**Regarding: 2005– 2007 Model Year Yamaha YP400 and
2006 – 2007 CP250 Fuel Pump Coupler Factory Modification Campaign**

Technical BULLETIN

RECALL

2006~2007 CP250 (Morphous); 2005~2007 YP400 (Majesty) FACTORY MODIFICATION CAMPAIGN – Fuel Pump Harness

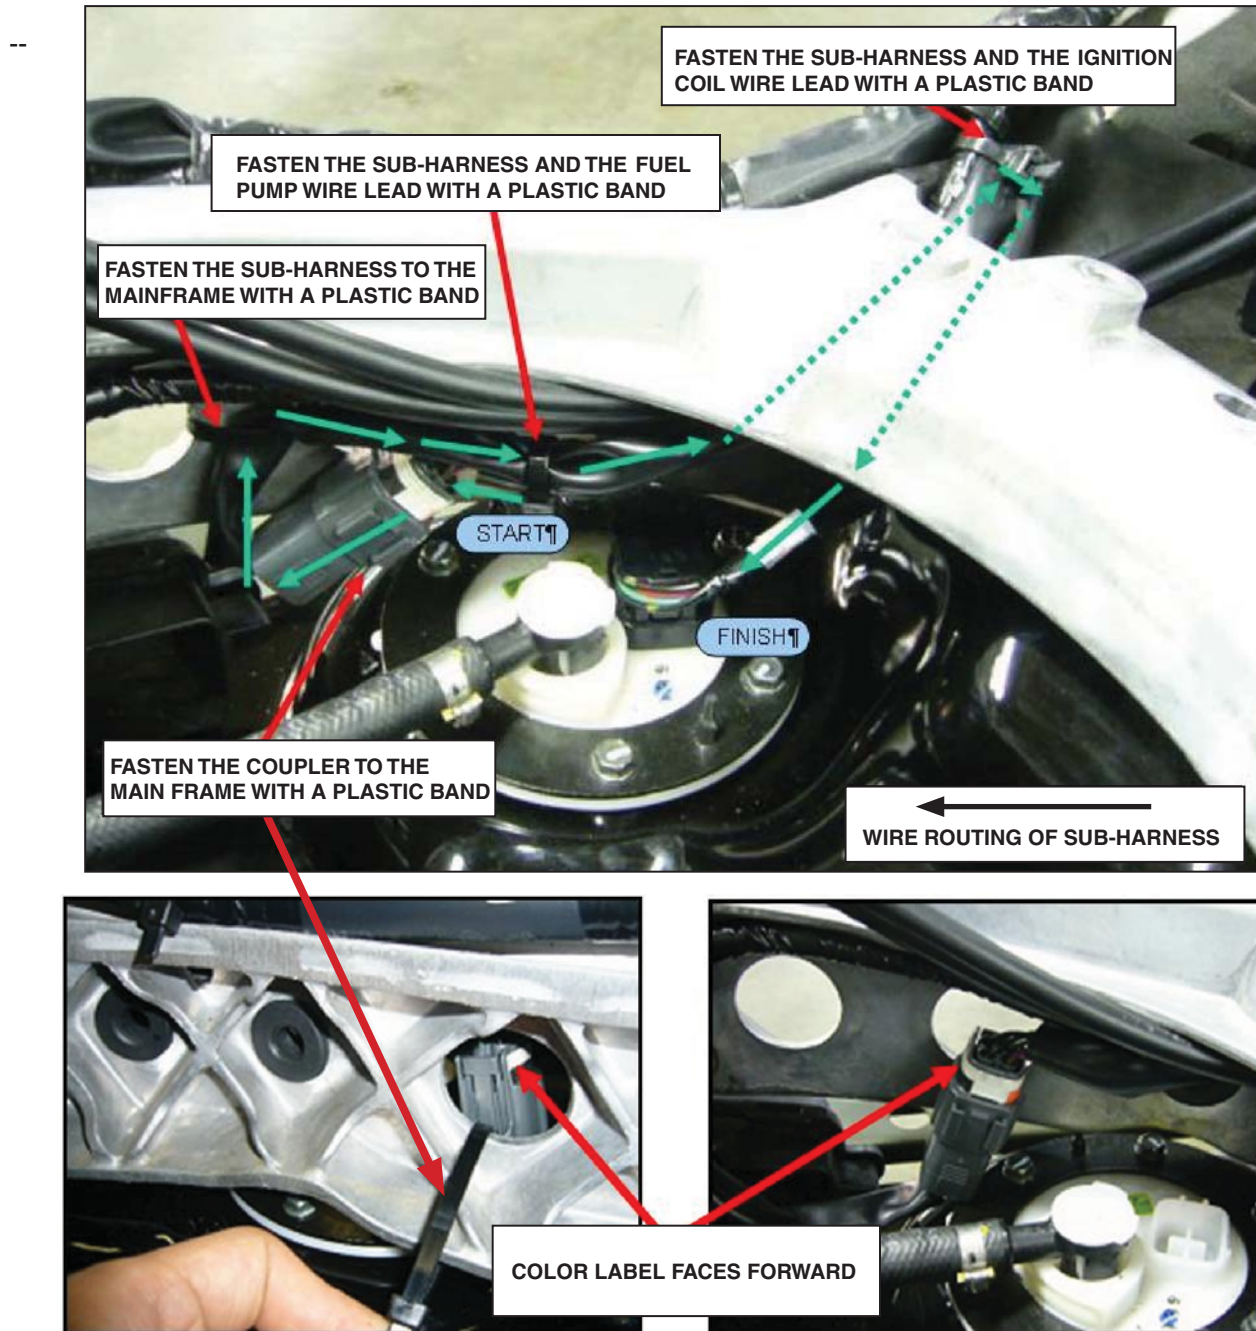
6. Secure the fuel pump sub-harness with the supplied plastic bands (zip ties) as shown.

Be sure to secure the fuel pump sub-harness as shown. This positions the wire harness coupler of the main wire harness in a position that will allow any water that enters the wire harness to drain out.

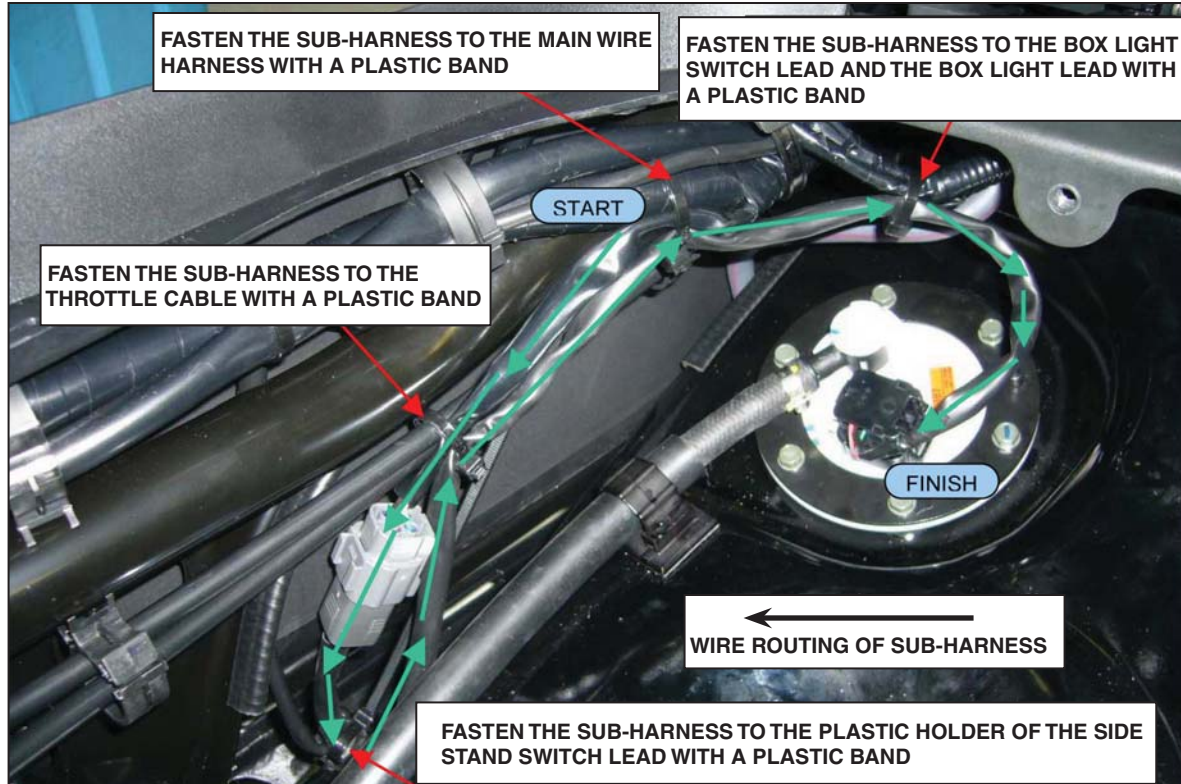
10. Secure the fuel pump sub-harness with the supplied plastic bands (zip ties) as shown.

Be sure to secure the fuel pump sub-harness as shown below. This positions the wire harness coupler of the main wire harness in a position that will allow any water that enters the wire harness to drain.

IDENTIFICATION PROCEDURE

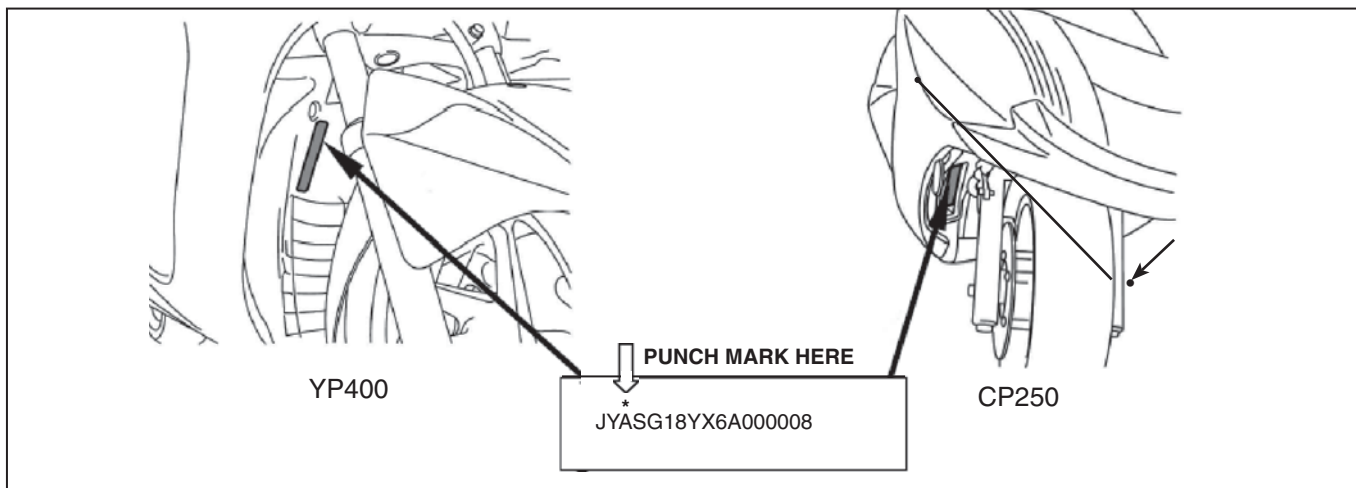
When the modification is complete, put a punch mark next to the Primary ID as shown. Check for this punch mark if you encounter an unfamiliar unit. You can also check unit status on YDS or by contacting your Regional Technical Advisor.
